Re: Supplemental Information for the RCRA Permit Application Renewal, Safety-Kleen Systems, Inc. Service Center, Farmington, New Mexico (NMD980698849)

In a letter dated February 20, 2002, NMED/HWB requested additional supplemental information. A response to the NMED/HWB requests and the requested information is provided with this correspondence. Each of the NMED/HWB requests is retyped below for convenience. A response providing the supplemental information follows each of the NMED requests.

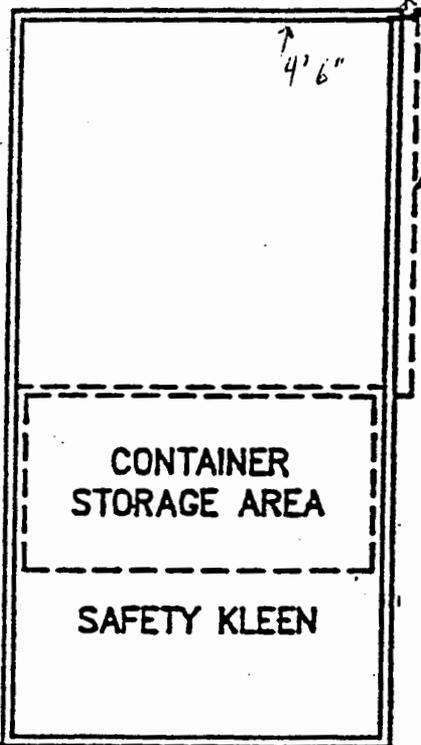
Attachment E, Preparedness and Prevention – Safety-Kleen shall verify that containers holding ignitable or reactive wastes are located at least 50 feet from the Facility's property line pursuant to 20.4.1.500 NMAC (incorporating 40 CFR 264.176). The Safety-Kleen Site Plan, Figure E-1, indicates that the west boundary of the container storage area is within the 50-foot requirement. Please indicate on any applicable drawings the location of these containers.

A hand drawing is attached indicating the position of the flammable waste relative to the property lines. The flammable waste is approximately 142 feet from the east edge of the property, 96 feet from the west edge of the property, 156 feet from the north property line, and 181 feet from the south property line. A mechanical drawing will be available within the next few days and will be forwarded immediately to you.
